Service Bulletin

RRP Service Bulletin No: RRP SB350

Title: Replace ATPI Lifting Plate (RRP Kit # 793070)

Product Series: Advance Tie Plate Inserter [ATPI]

Remove Existing Lift Plate

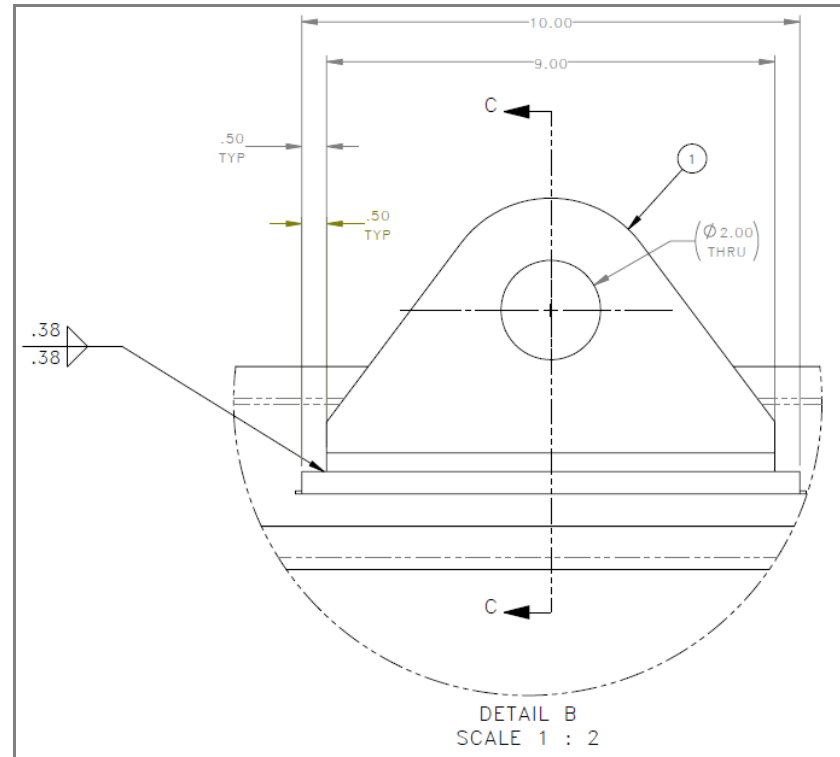
Summary: The lift plate must be replaced to provide an additional safety factor.

Action: Replace existing Lifting Plate with new Lifting Plate Kit RRP# 793070. See attached for instructions.
